Title & Document Type: 4328A Milliohmmeter Operating and Service Manual

Manual Part Number: 04328-90008

Revision Date: March 1989

This supplement contains information for correcting manual errors and for adapting the manual to newer instruments that contain improvements or modifications not documented in the existing manual.

Figure 4-5 MODEL 4328A PHASE - SENSITIVE AMPLIFIER TALKING SCHEMATIC -\*\*\*

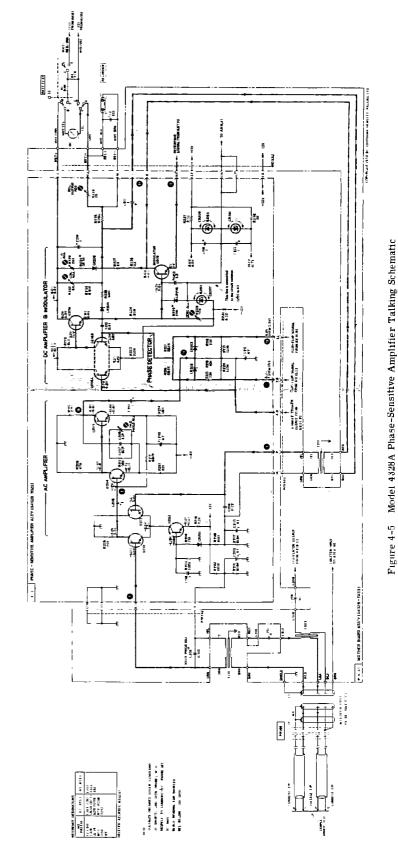
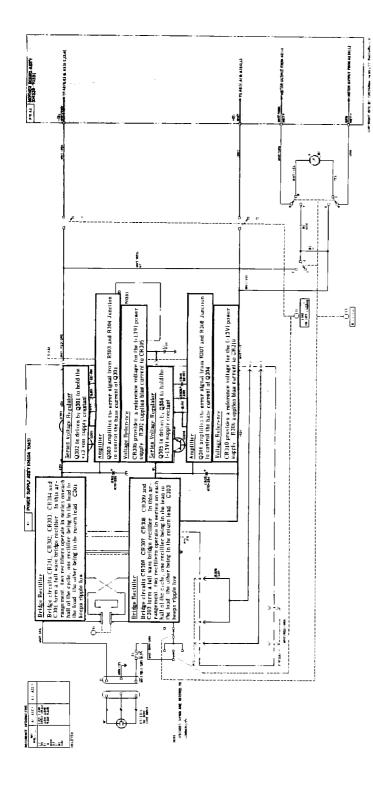
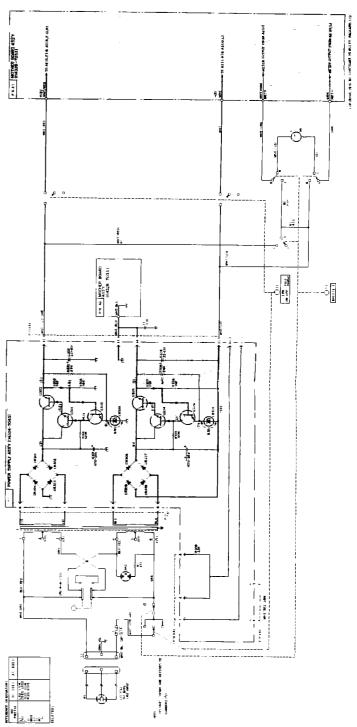
Page 4-7, Figure 4-5 and Page 8-19, Figure 8-17, A2 PHASE-SENSITIVE AMPLIFIER Assy. :

Change the value of R230<sup>t</sup> to 56k $\Omega$ .

Page 4-7, Figure 4-5 and Page 8-19, Figure 8-17, A2 PHASE-SENSITIVE AMPLIFIER Assy. : Change the value of R234<sup>\*</sup> to  $3.16k\Omega$ .

Page 4-7, Figure 4-5, Delete A2C218.

Figure 5-3.  $(90\Omega + j 180\Omega)$  Impedance

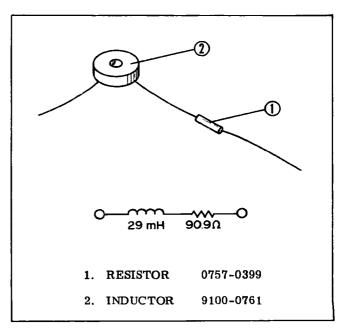
Page 5-7, Figure 5-3,  $(90\Omega + j180\Omega)$  Impedance:

Change the Part Number for the INDUCTOR to 9100-1686.

Figure 8-14. Oscillator Ass'y A3 Range Switch Ass'y A4 Mother Board Ass'y A5

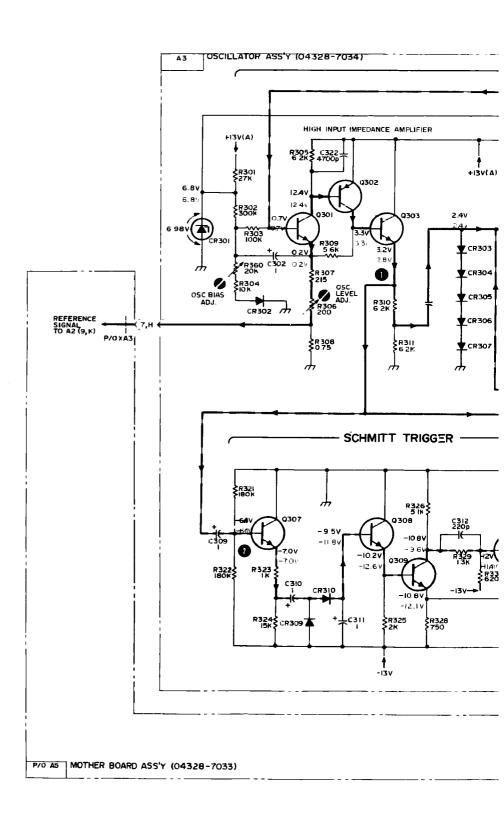
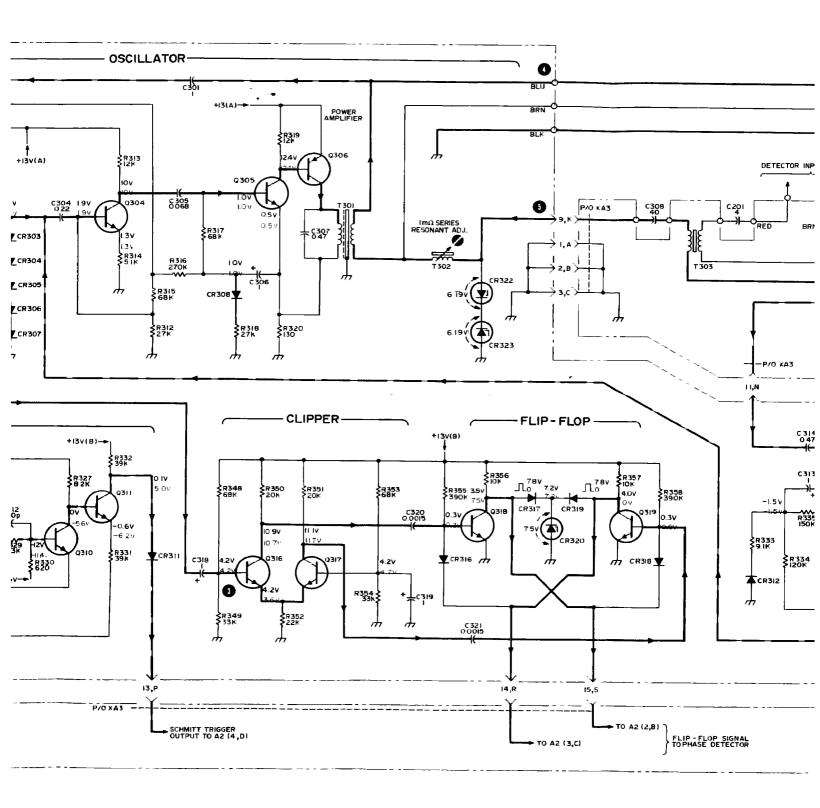
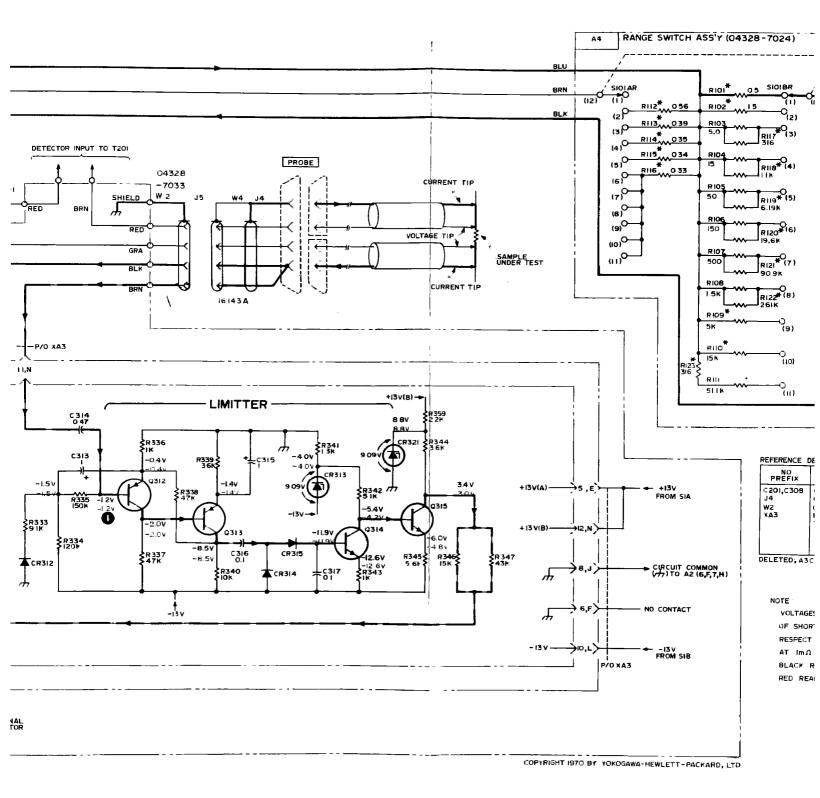
Page 8-17, Figure 8-14: A3 OSCILLATOR Assy.

Change the value of R335 to  $133k\Omega$ .

Page 8-17, Figure 8-14

Change a part of A3 schematic as follows:

Page 8-17, Figure 8-14

Change A4R112 to 750m $\Omega$ , A4R113 to 490m $\Omega$ , A4R114 to 430m $\Omega$ , A4R115 to 414m $\Omega$  and A4R116 to 406m $\Omega$ .

Page 8-17, Figure 8-14

Change A3R303 to 390k $\Omega$ , A3R304 to 39k $\Omega$ , A3R305 to 10k $\Omega$ , A3R310 to 15k $\Omega$ , A3R311 to 5. 1k $\Omega$ , A3R313 to 68k $\Omega$ , A3R314 to 12k $\Omega$  and A3R323 to 3. 3k $\Omega$ .

Page 8-17, Figure 8-14 Delete A3C322.

Page 8-17, Figure 8-14
Delete A3CR322 and A3CR323
Change A3R304 to 20kΩ,
Delete A3R360 and replace with a short circuit.

Page 8-17, Figure 8-14, Change voltages of CR322 and CR323 to 5.9V.

Figure 8-17 PHASE SENSITIVE AMPLIFIER ASS'Y A2 MOTHER BOARD ASS'Y A5

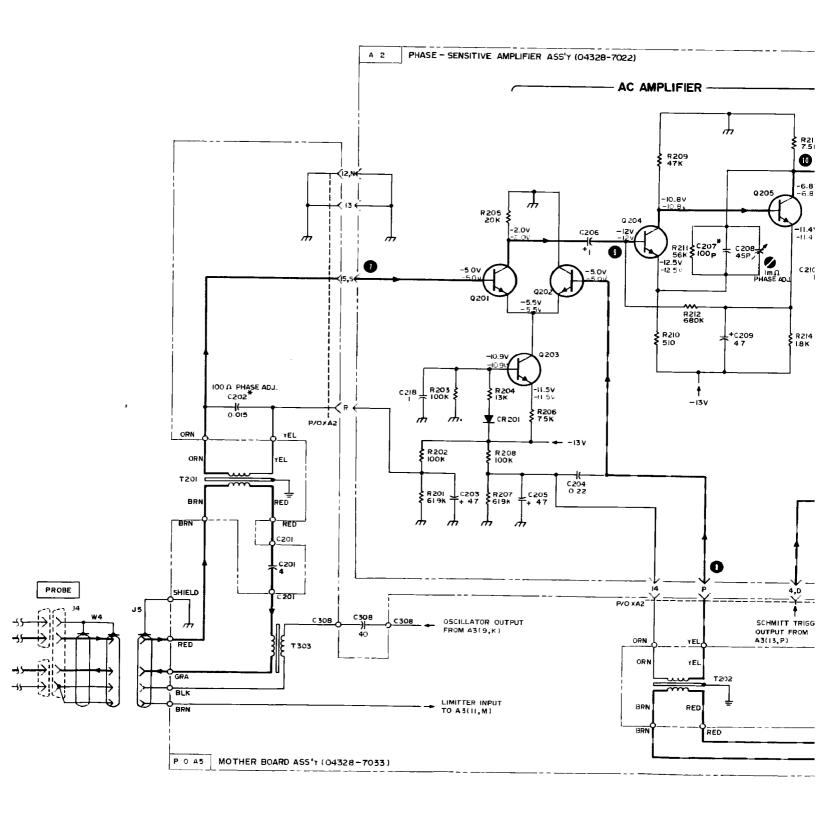
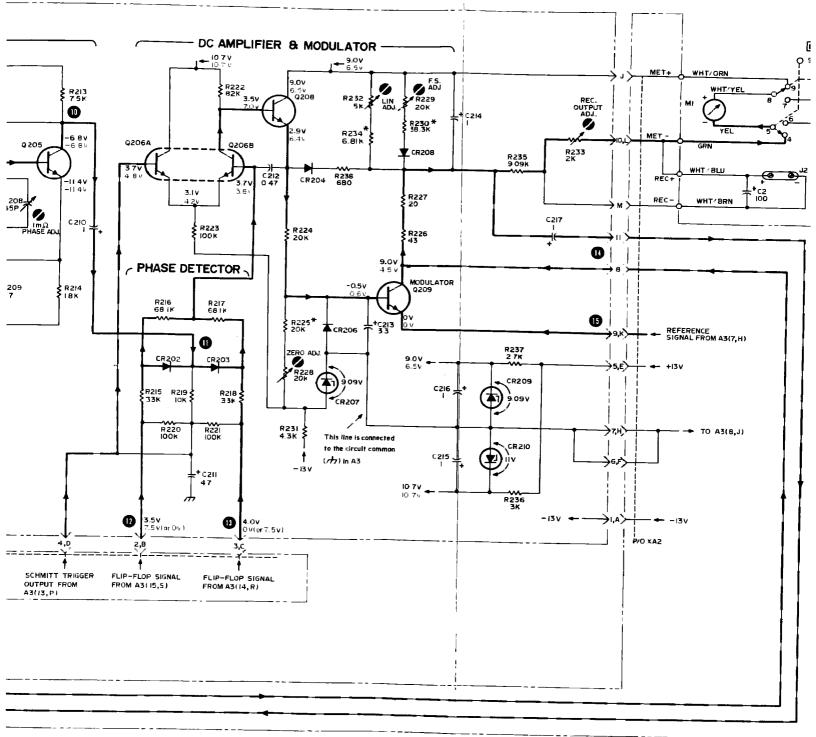
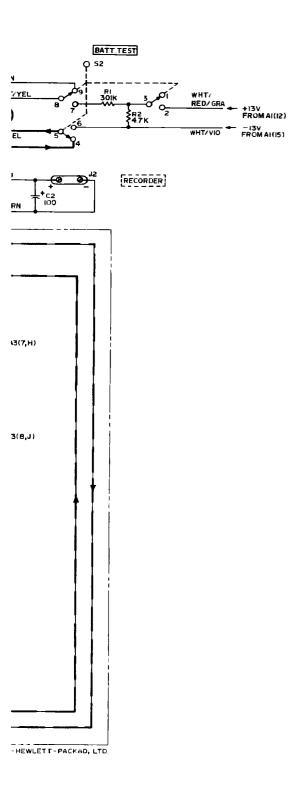
Page 8-19, Figure 8-17, Delete A2C218.

Page 6-4, Table 6-2, Page 8-19, Figure 8-17, Change A2C207 to HP Part No. 0140-0193, C FXD MICA 82pF 5% 300VDCW.

Page 6-4, Table 6-2, Page 8-19, Figure 8-17, Change A2C207 to HP Part No. 0160-2204, C:FXD MICA 100pF 5<sup>or</sup><sub>10</sub> 300VDCW.

Figure 8-19 Power Supply Ass'y A1 Mother Board Ass'y A5

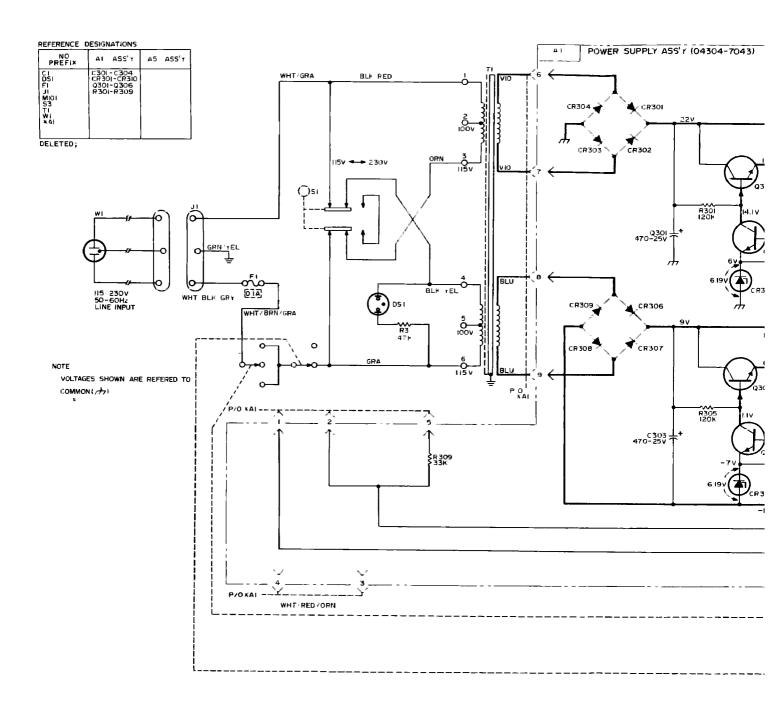
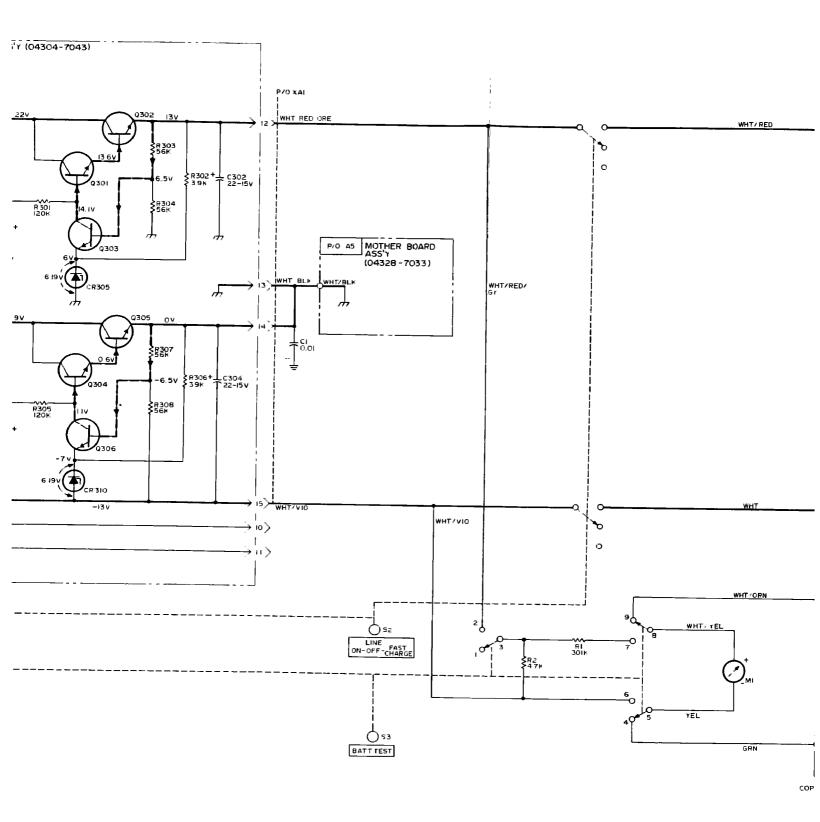
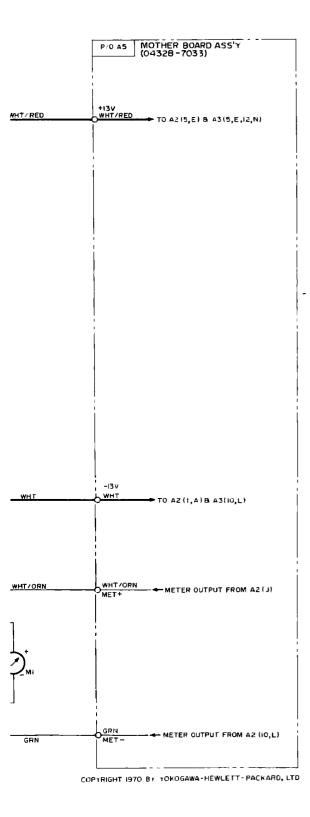
Page 8-21, Figure 8-19:

Change the value of R3 to  $33k\Omega$ .

Figure 8-21 Mother Board Ass'y A5 Ni-Cd Power Supply Ass'y A6

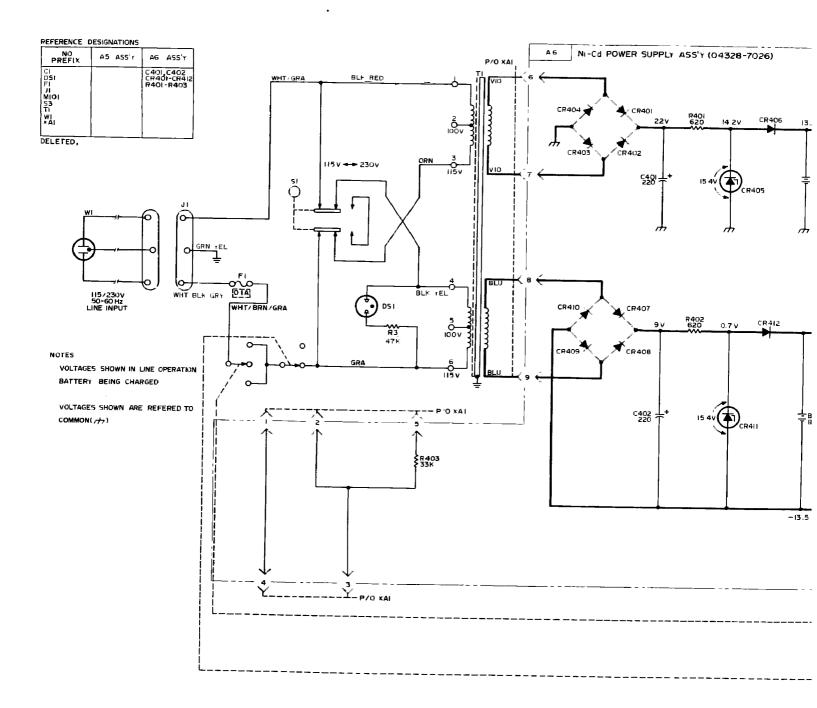
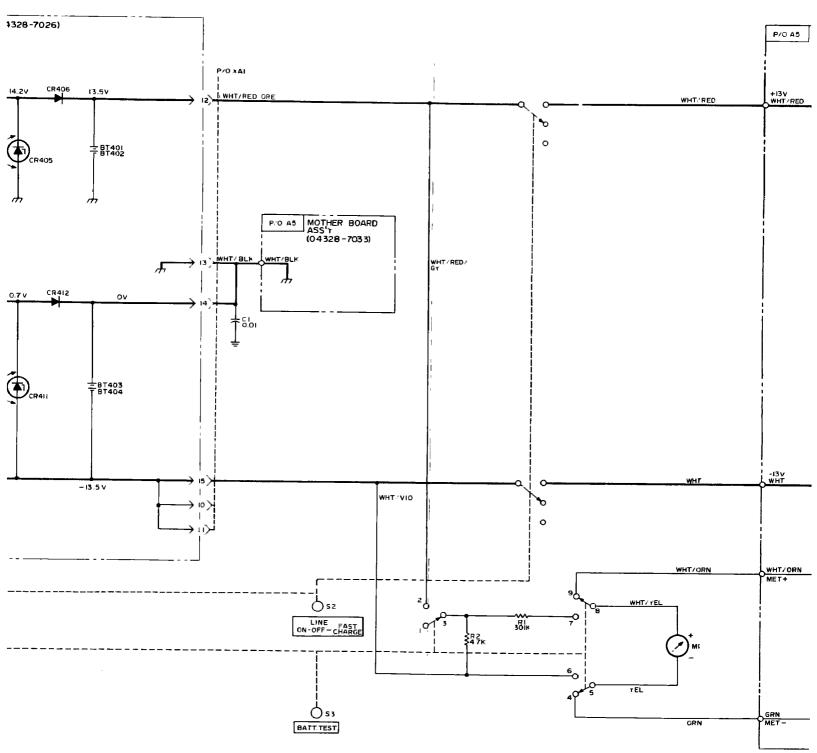
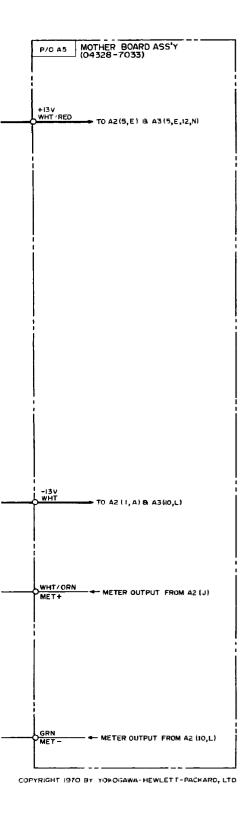
Page 8-23, Figure 8-21:

Change the value of R3 to  $33k\Omega$ .
